> RE: Preliminary Plan and Traffic Impact Study (TIS) Letter-**Revised** Plan No. 120230160 9801 Georgia Avenue

This letter supersedes the previous letter dated February 5, 2024. We have completed our review of the revised Preliminary Plan uploaded in eplans dated January 5, 2024, and revised TIS dated November 6, 2023. The plan was reviewed by the Development Review Committee at its meeting on September 12, 2023.

Plan Number: 1-20230160

Project Name: 9801 Georgia Avenue

Woodland Drive - Loading Entrance

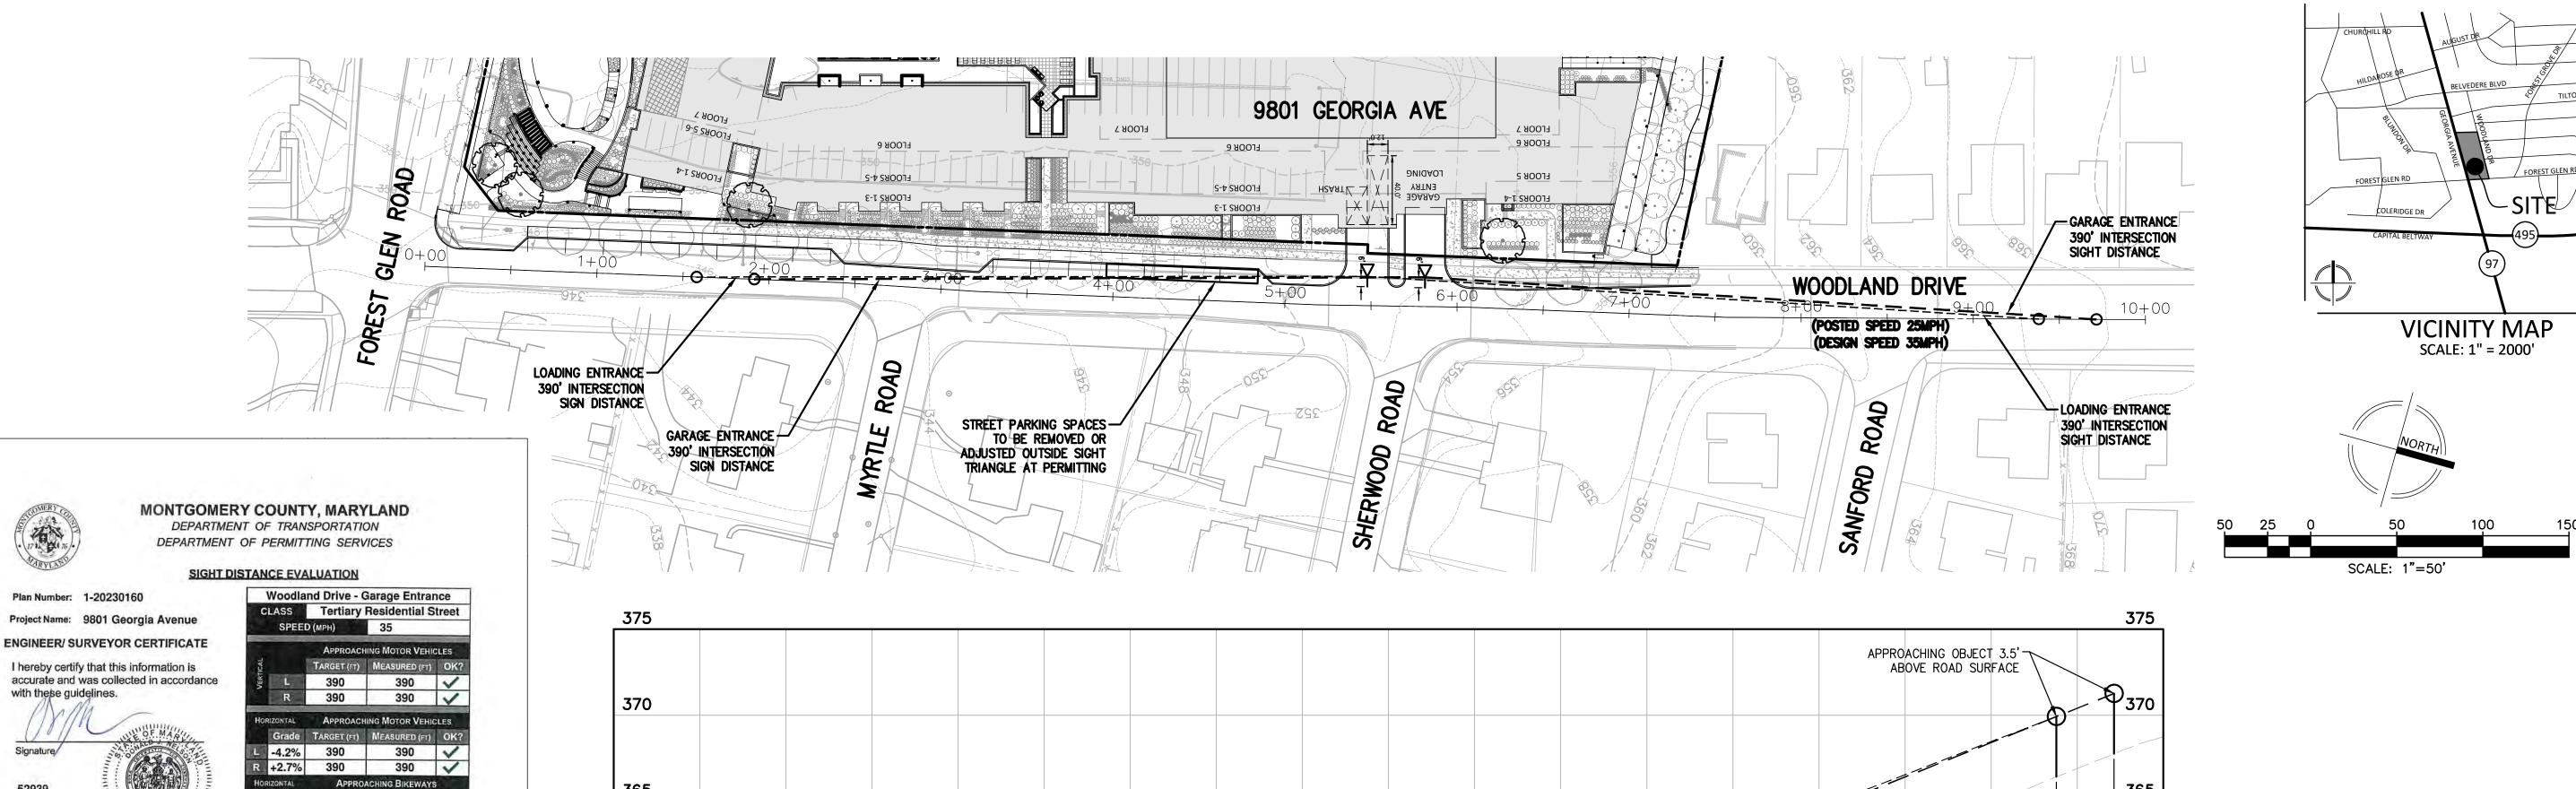
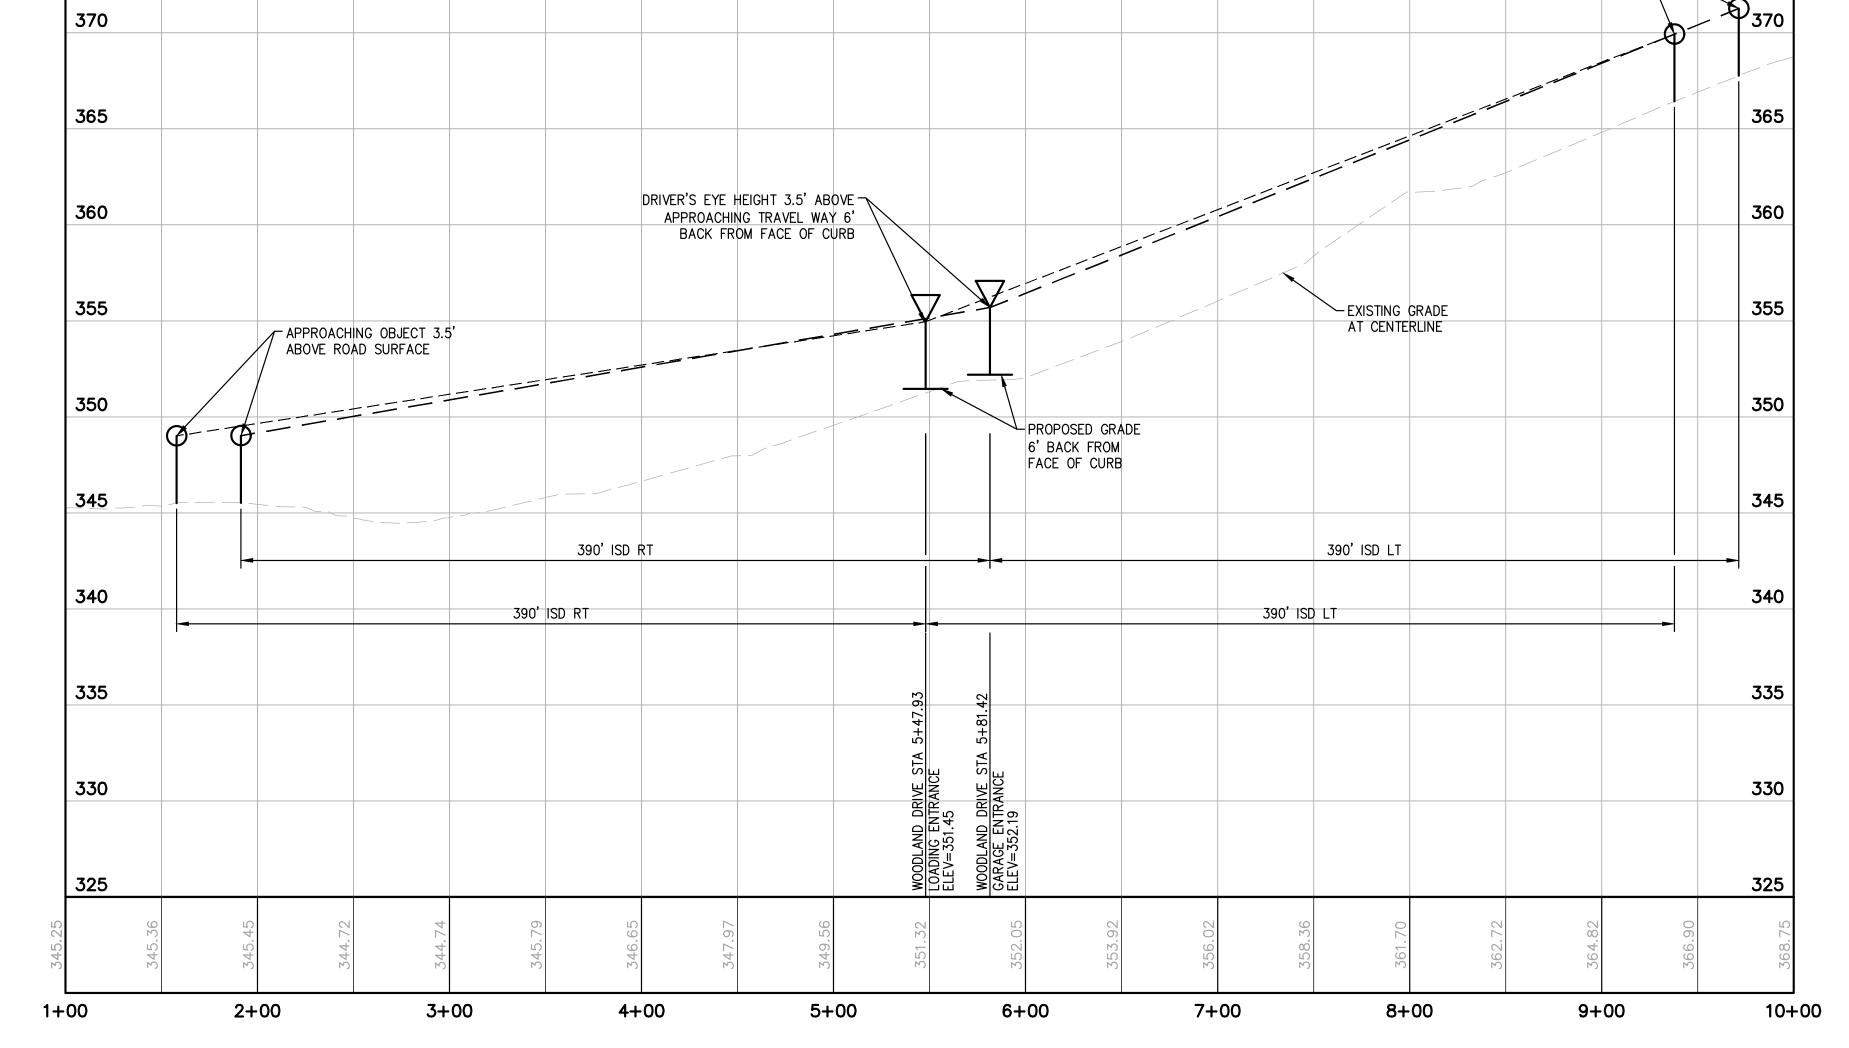
Street parking spaces to be removed and/or relocated outside sight triangles at permitting

Street parking spaces to be removed and/or relocated outside sight triangles at permitting

COMMENTS Per Speed Study included in the LATR Report dated

0/20/23 prepared by Lenhart Traffic Consulting, Inc, the 85th Percentile speed for Woodland Dr is 35mp

GEORGIA AVENUE

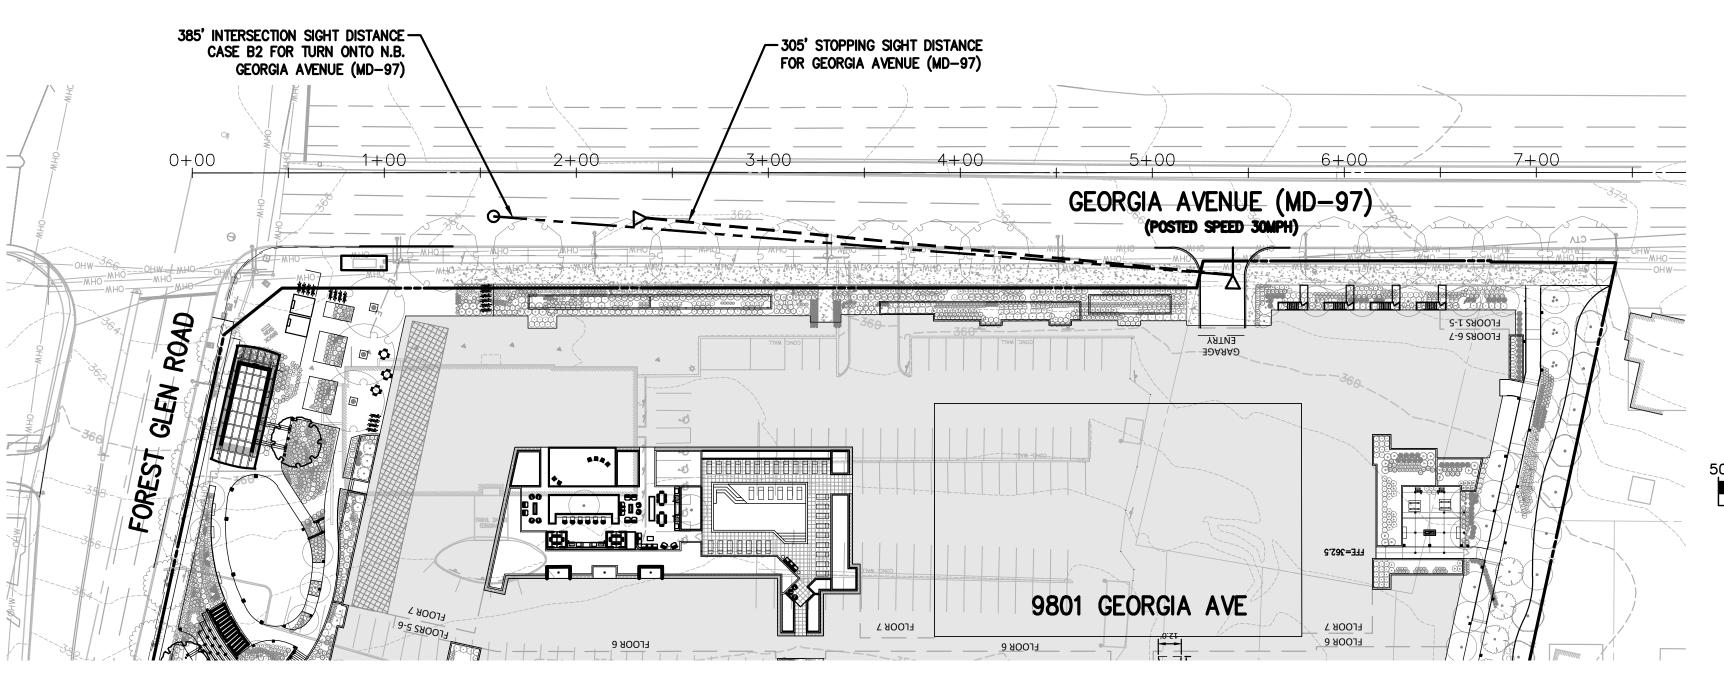
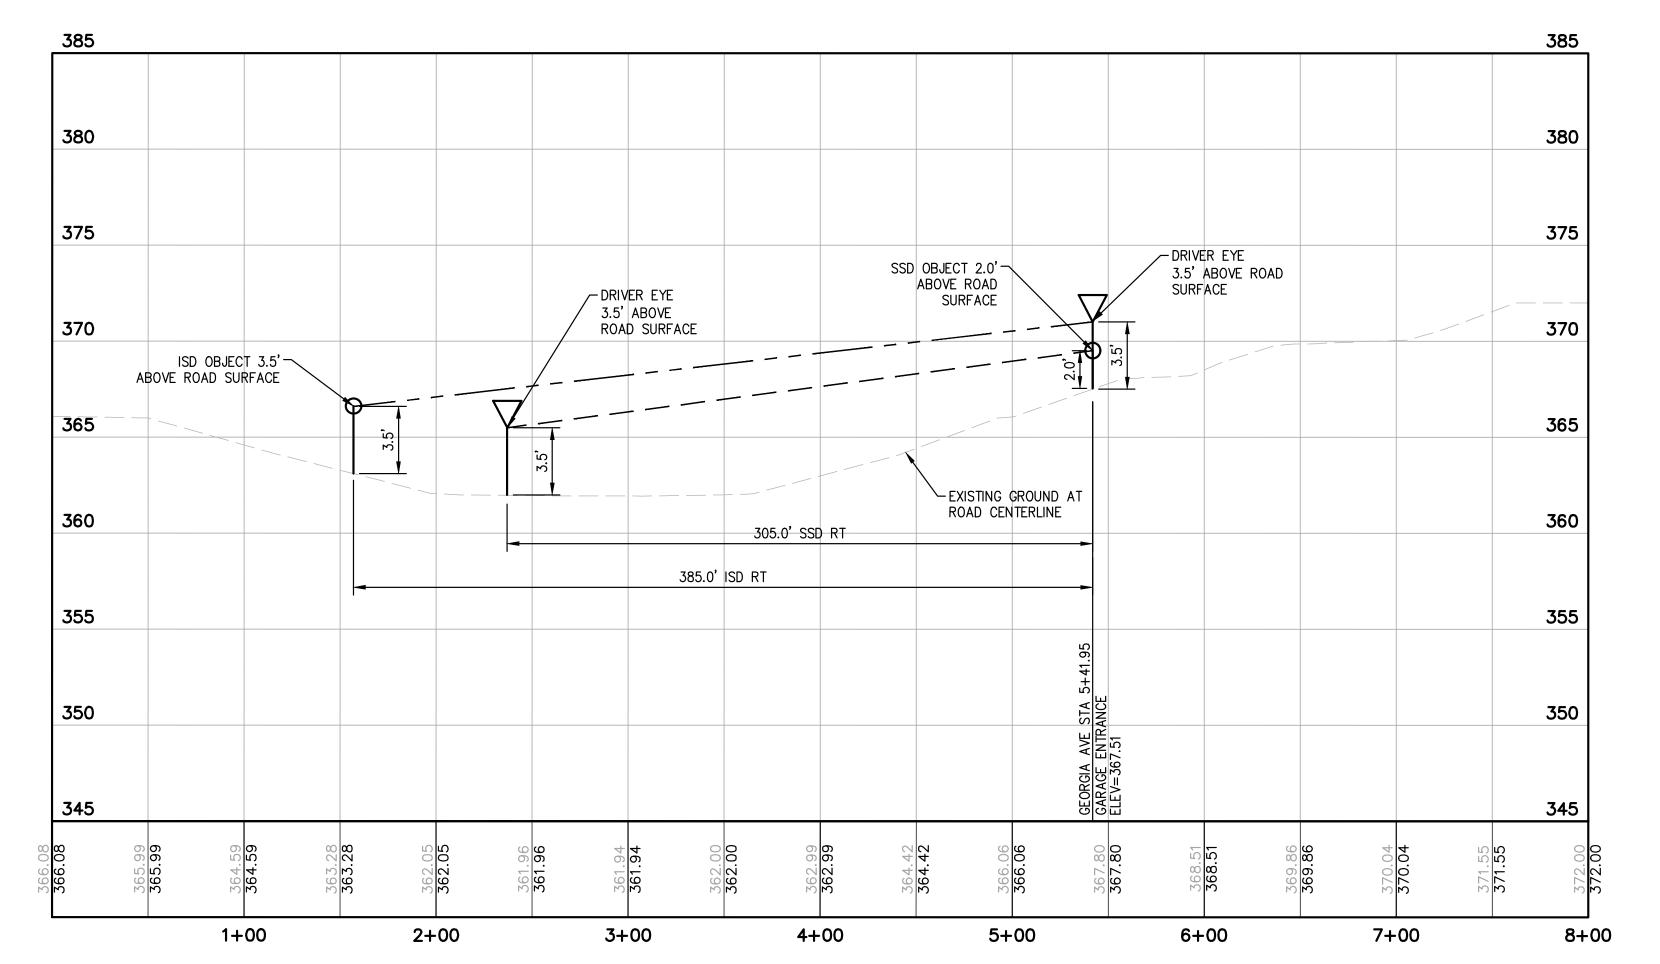
Posted Speed = 30 mph

Designed Speed = Posted Speed + 10 mph = 40 mph (EAPD Policy)

Turning Movement	State Standard ISD Requirement Based on Design Speed	Reduced ISD Requirement Based on Posted Speed*
Right Turn from Driveway 1 Stop Control, AASHTO Case B2 (2018 AASHTO Greenbook Table 9-9)	385 ft	290 ft

Stopping Sight Distance (SSD): SSD Required for the Design Speed: 305 ft (2018 AASHTO Greenbook, Chapter Table 3-1)
